CHANGE ORDER #7

New Pro Shop and Cart

Storage Facilities

Re: Concrete pad

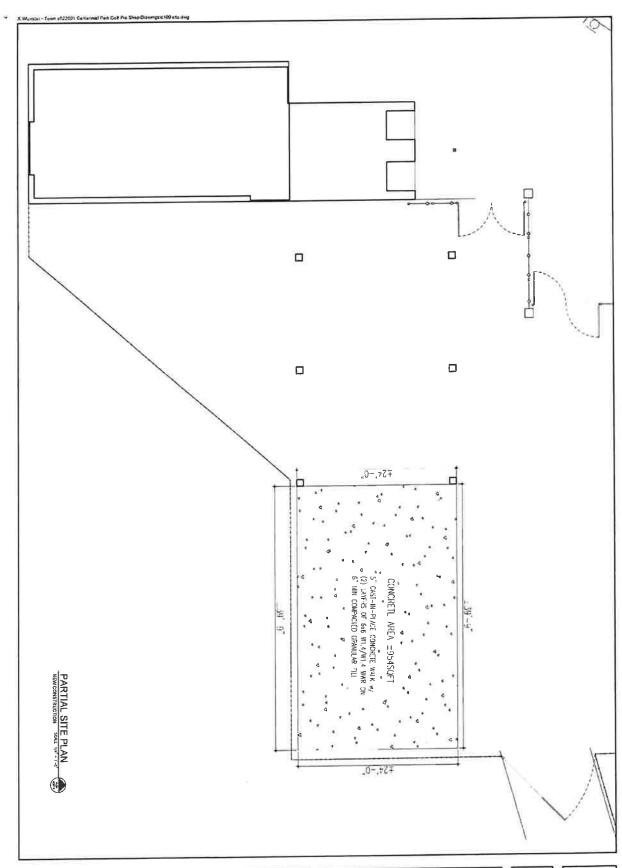
- 1) Excavate for new 40 x 24 concrete slab
- 2) Import sand to build up ditch to support new concrete slab
- 3) Import 6" of #53 crushed concrete for slab
